COUNCIL ASSESSMENT REPORT

| DA Number | DA 1103/2018/JP |
| Proposed Development | Demolition of existing structures, construction of local roads and 78 townhouses. |
| Street Address | Lot 86 DP 10157 No. 29 Hynds Road Box Hill |

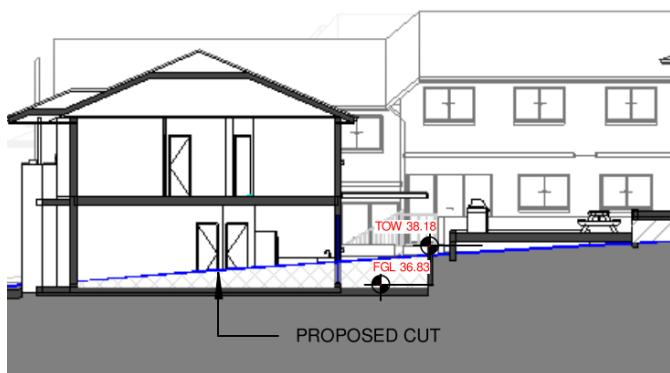
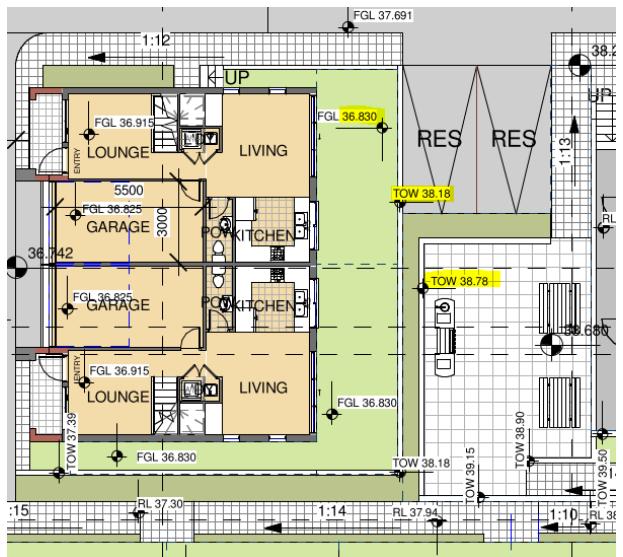
The site slopes steadily from north to south with a difference of 14 metres between the northern and southern ends of the site. The architectural plans illustrate a development that is stepped in response to the slope of the site and incorporates some retaining walls. The DCP requires that all retaining walls are shown on the plans. Whilst some walls and wall heights have been provided on the plans, proposed differences in levels shown on the plans suggest that more retaining walls than are shown on the plans are required. Examples include the following:

In addition to the plans lacking detail, there is some proposed stepping and use of retaining walls within the site that is considered to result in undesirable outcomes for future residents.

Townhouses 60 and 61 and corresponding section

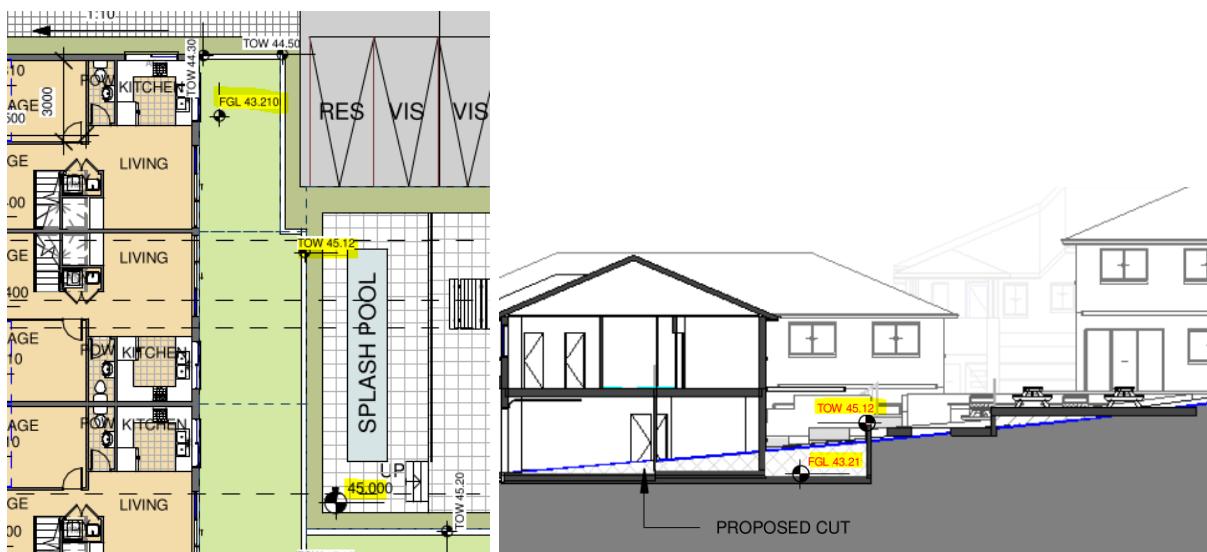
A 1.95m difference between a common open space area and immediately adjacent private open space is the result of proposed cut at the rear of townhouse Nos. 60 and 61. It is noted that the retaining walls have been tiered however with a dividing fence proposed on the lower tier, will result in overlooking from the common open space to private open space, in addition to a total 3.15m combined wall and fence height to the private open space which is unacceptable.

Townhouses 74-76 and corresponding section

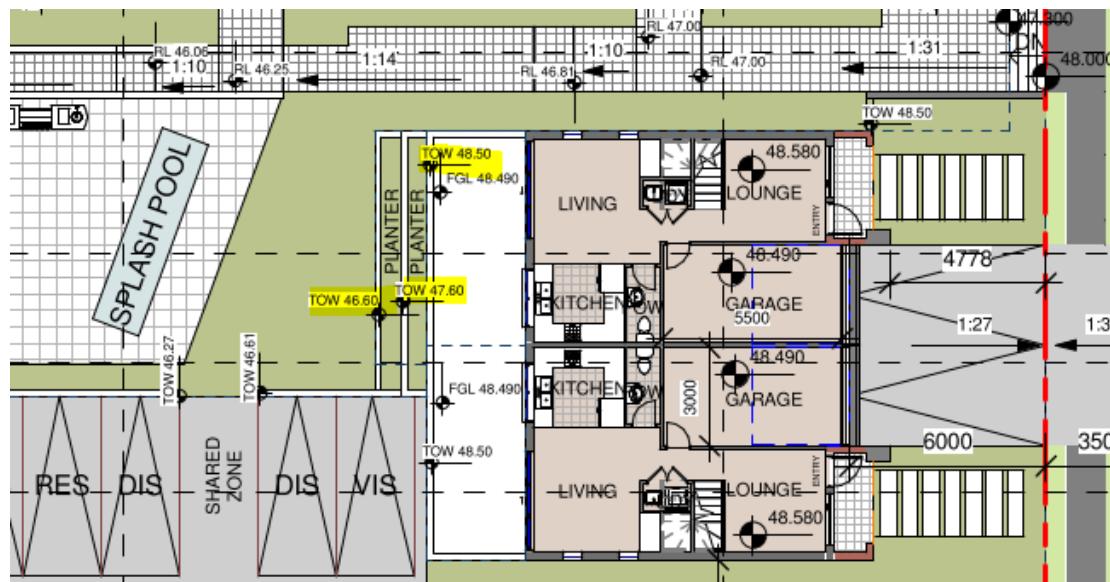
A 1.79m difference between the common open space area, including pool, and private open space area is the result of proposed cut at the rear of townhouse Nos. 74-76 and between townhouse Nos. 77-78 and 35. A retaining wall of 1.91m is proposed. The pool line is located approximately 1.6m from the private open space fence line. Together with a fence of up to 1.8m, the private open space may have a rear wall height of up to 3.71 metres. Whilst the actual cut proposed is reasonable within the context of the sloping site, the management of this cut with a single retaining wall, the nature of the proposed private and common open space interfaces and proposed total fence heights will not result in an acceptable amenity outcome for residents.

Proposed location of lifts in relation to adaptable housing

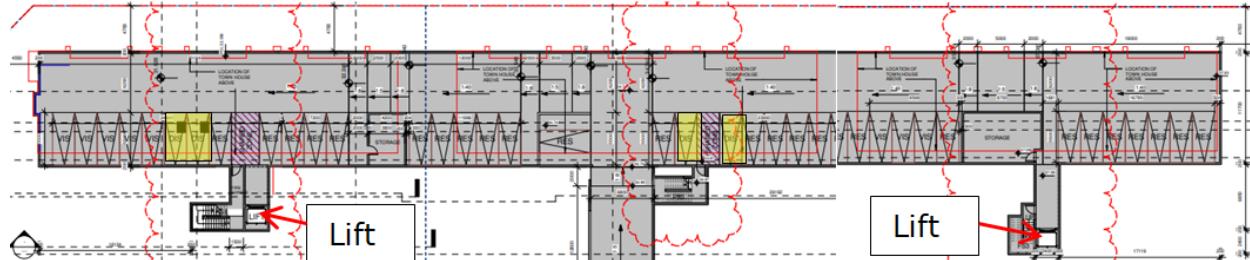
All adaptable dwellings are proposed to be located on the western side of the site. Since no vehicular access to the site is available via future Sagitta Street, no garages are provided to these dwellings. The dwellings are proposed to be provided with basement car parking only, accessible via two lifts which surface within the outdoor circulation/common areas of the development. Residents are then required to access their dwelling via pathways to the rear of the dwelling / private open space and the living room/sliding door.

Furthermore, only four spaces have been provided as designated as disabled parking spaces within the basement. Two of the designated basement disabled spaces have not been provided with the required shared area, and two are not positioned in the most convenient position adjacent to a lift. A further 8 disabled parking spaces are provided within the development, however the majority of these are not located in close proximity to the adaptable dwellings.

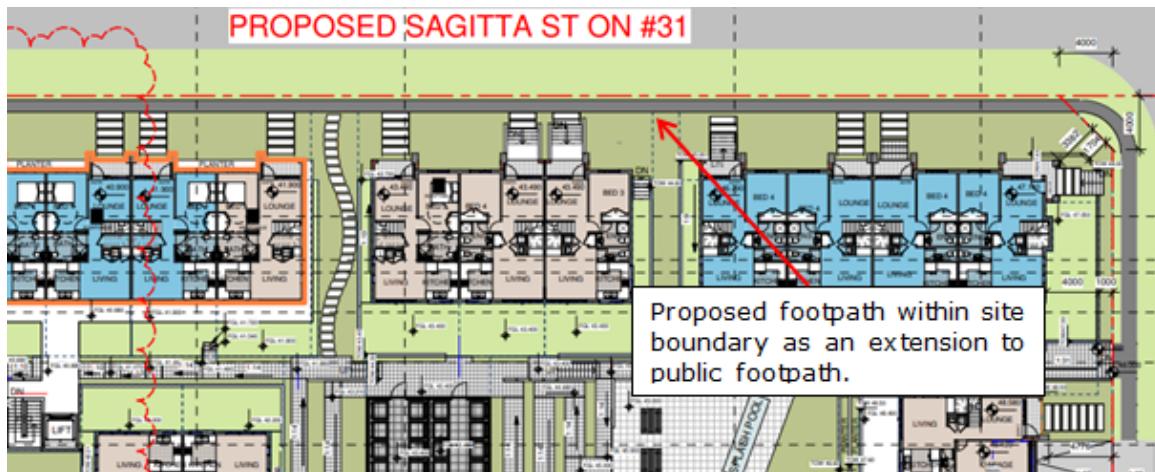
Hourly shadow diagrams have been provided by the applicant, however a table detailing the solar access received by each private open space area has not been provided to accompany the diagrams. It is difficult therefore to assess the percentage of townhouses that receive 3 hours of sunlight.

Due to the slope of the land (14 metres from north to south), the orientation of the site, and the terracing of land required to accommodate the proposed dwellings, it is challenging for the development to achieve reasonable solar access. As outlined in relation to cut and fill and retaining walls, some private open space areas will not provide adequate amenity for residents due to wall heights. Better outcomes could have been achieved for these units through better management of cut and fill and an increase in private open space areas to allow for terracing of retaining walls for example. It is noted however that the development does provide private open space areas that are all in excess of the minimum (ranging from 19.15m² to 70.98m²).

Insufficient information has been provided to enable a full assessment of solar access to private open space areas.

Proposed Lift Shafts

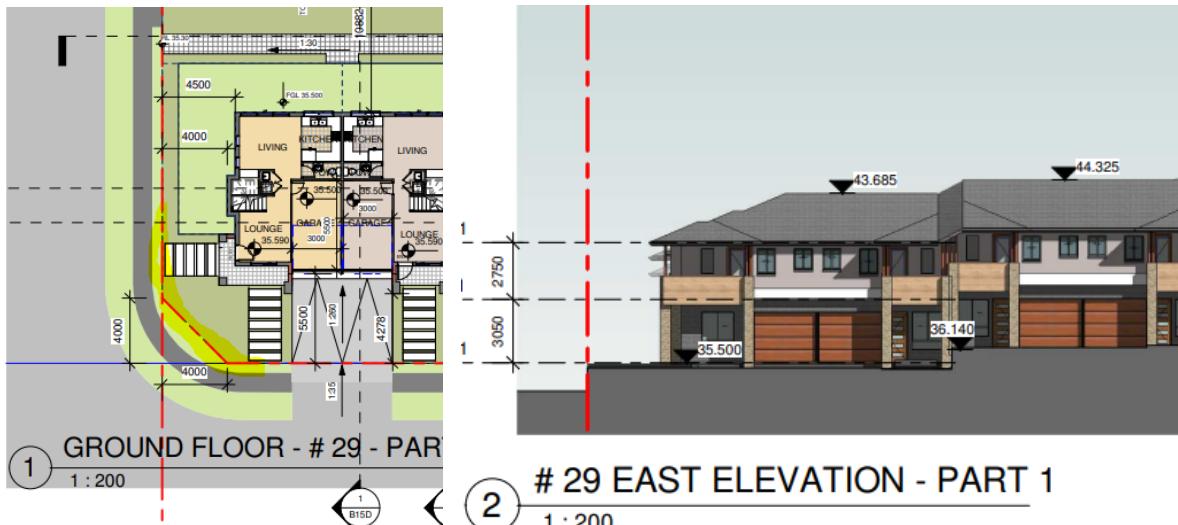
Concern is also raised in relation to the visual impacts of proposed lift shafts within the development both within common circulation areas and in relation to adjacent private open space areas. The provided Sections indicate that the lift shafts will be imposing structures.

Retaining walls not shown.

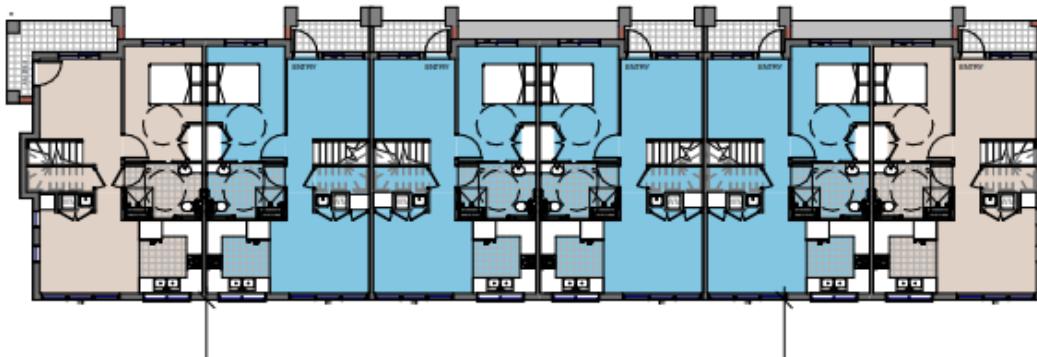
- Spot levels are not provided in the front setback areas and road reserves;
- Section plans and proposed spot levels indicate that that retaining walls will be required between some private open space and front setback areas which are not shown on the plans. For example, on the Hynds Road and Zaniah Street boundaries of the site adjacent to Townhouse No. 49, between Townhouses 32 and 33 (front setback), between Townhouses 57 and 43);

Lack of spot levels and no retaining wall shown as required according to street elevation.

ATTACHMENT 14 – LANDSCAPE PLAN (1)

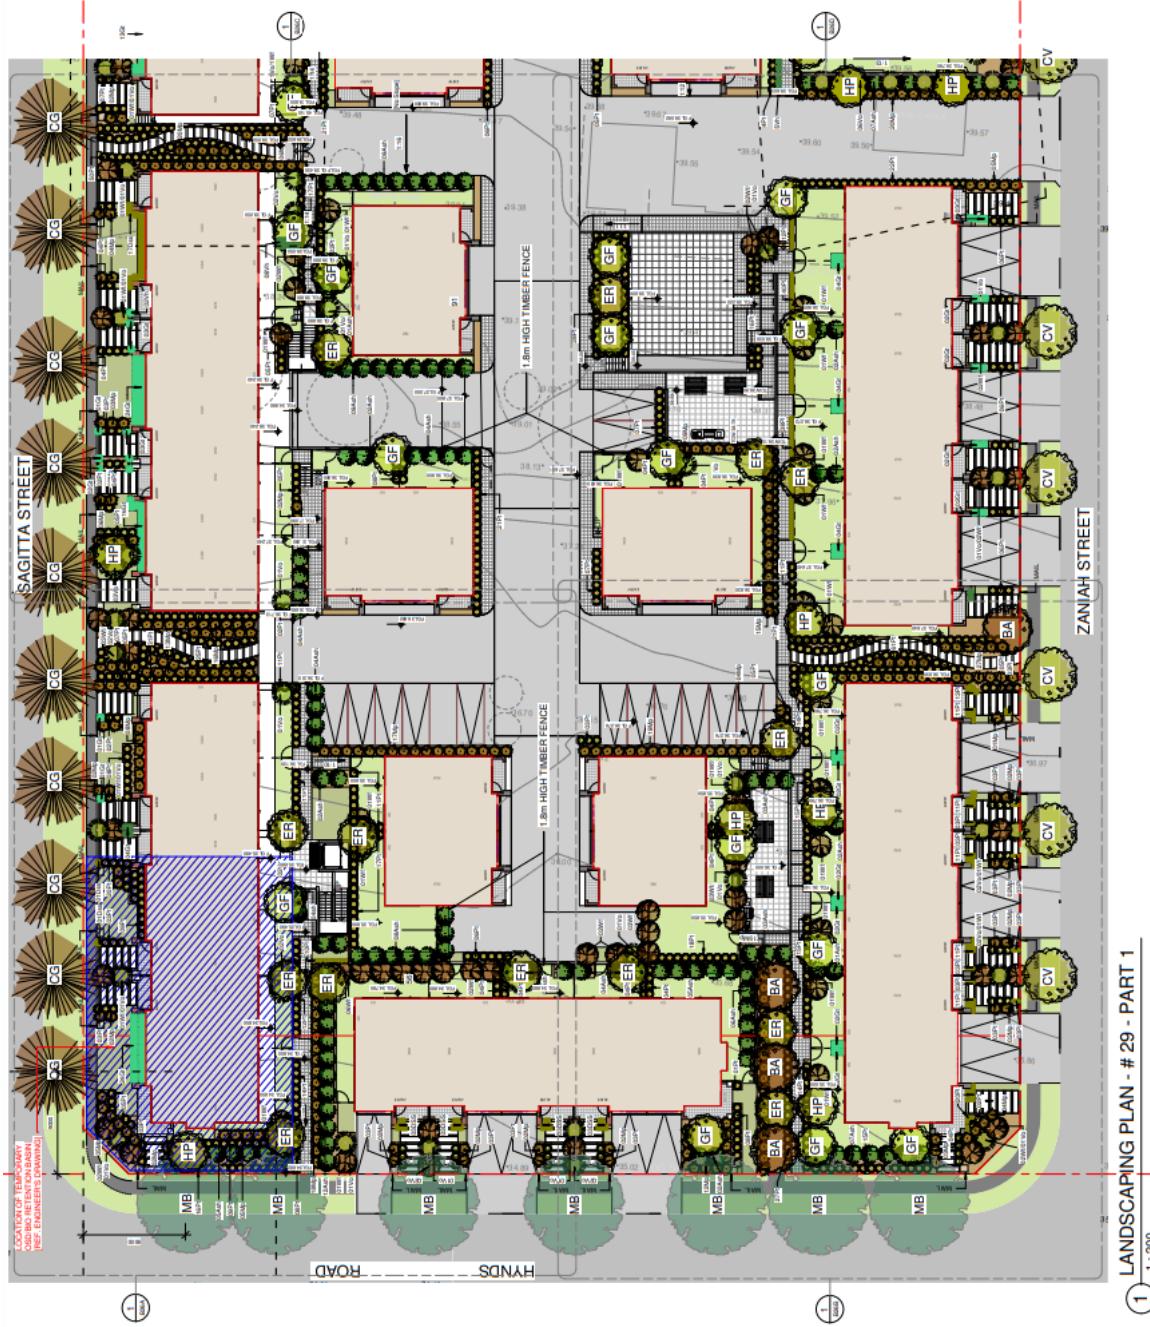
1. Further site levels are required to all external areas as there are many areas which are currently unresolved. Additional retaining walls and steps are required and resolution of pedestrian circulation to cater for level changes between units, driveways and communal open space. Top off wall levels are required to all retaining walls and paths in addition to proposed levels to boundaries in accordance with road design. Internal landscaping Section Plans are required to demonstrate treatment of level changes and planting is to be adjusted in accordance with retaining walls and levels. Tier walling where required to reduce the impact of high walls with fences on top. A 3.1m high wall and fence structure to courtyards is not acceptable.

2. Replace Viola (VH) proposed to western boundary with DSS or GT as too hot for the shade species Viola.
3. Placement of BBQs in close proximity to private open space is not recommended. BBQ's are to be relocated off boundary fences. Review an option for a large turfed open space area where suitable to provide a variety of communal areas as all are paved.

4. Stormwater design, lines and pits are not shown on Landscape Plans as required.
5. Street Trees to Sagitta Street are to be amended to *Eucalyptus haemastoma* as per the larger variety as per Box Hill Street Tree Masterplan due to the pedestrian paths for the street being within the boundary.

7. *There are significant areas of garden which are hatched in brown with no associated hatch in the legend. These areas appear to be mulched. Areas of mulch, including to frontages of units are to be planted, rather than only provided with mulch.*
8. *There are also areas depicted in white, which correlates with mulch in the legend. These areas are to be planted, with spaced stepping stones provided if required.*
9. *Bin storage areas are not clearly identified on the Landscape Plans (shown only as tiled areas) and do not show proposed walls and doors as identified on the Architectural Plans.*
